Subject Number	Subject/Comment	Comment Numbers	DGEIS/Guide Book References	Response
EIS-C	Cover			
EIS-C1	Why is this document Prepared by: Bergmann and New York Power Authority	1045	EIS Cover	The New York State Canal Corporation (NYSCC) is a subsidiary of the New York Power Authority. The NYSCC has jurisdiction of and responsibility for maintaining the earthen embankments. Bergmann was competitively procured to provide support for development of Earthen Embankment Guidebook and completion of State Environmental Quality Review Act requirements.
EIS-1	SEQR and Description of Proposed Action			
EIS-1.1	Project Background			
EIS-1.1a	Is the proposed tree removal influenced by differences between maintenance strategies by previous NY Thruway Authority and NYPA? i.e., budgetary and/or resource changes? What has changed that now requires the canal to be clear cut? The only thing I can discern is that the NYPA took control of the canal corporation and it's just administratively easier to clear cut.	1022, 1023		Best Management Practices (Army Corp of Engineer, Federal Emergency Management Authority) and regulatory requirements for similar structures as well as programs implemented by other

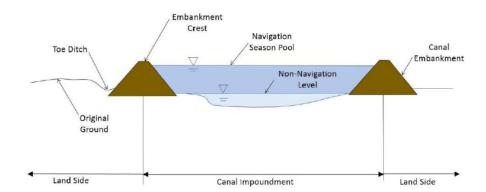
Appendix B Risk Exposure Presented by Canal Embankments			
Аррх ВЬ	DGEIS Appendix B Page B-6: According to Table B-4, probability of seepage induced failure is listed as 3.5×10^{-3} for levees, canals and dams, not 3.5×10^{-5} as described in the text. Please confirm the appropriate probability, as 3.5×10^{-3} appears to b incorrect.	1015		The probability of seepage induced failure in Table B-4 is 3.5×10^{-3} for levees, canals and dams which is correct. That is before applying the event probability. The reference to 3.5×10^{-5} in the text above is incorrect and will be changed to 3.5×10^{-3}
Аррх Вс	DGEIS Appendix B Page B-8: The Town would like NYSCC to provide specific risk based inundation mapping of critical low areas along the canal embankment, in particular between Canal Mile Marker 248 and 251. This would provide helpful information to share with residents and business owners in key areas in Town (e.g. Burgundy Basin, Indian Valley Subdivision Rochester Fair Garden Subdivision, Fairport Office Park).	1015		The extent of risk-based inundation mapping would be determined by the Canal Corporation and may be a component of future embankment section level projects.

Аррх Bd	Appendix B establishes an acceptable risk level, however it makes a general assumption about the danger of trees along the canal to justify the findings of the report. On page B-7, there is an assumption that the risk of failure due to seepage or poor maintenance is double that of one that has no seepage and is well maintained. However, the rationale for this is not explained which calls into question the conclusion. This should be removed, or explained using statistical evidence or supporting report documentation.	1050		The doubling factor is based on engineering estimates, and illustrates a key point that the exposure for embankment dams and canal embankments are about 2 orders of magnitude greater than for levees because of the difference in event probability.
Аррх Ве	The assumption on B-7 referenced above does not specify that trees add to the issue. It may be inferred, but it is also possible that poor maintenance and seepage occurs without trees. An additional assumption is inferred that trees are part of the poor maintenance for which cited reports within the EEIP do not provide evidence. Additional	1050		The text notes that tree and woody vegetation removal is a key component of managing risk by facilitating safety inspections and eliminating tree roosts as seepage hazards.
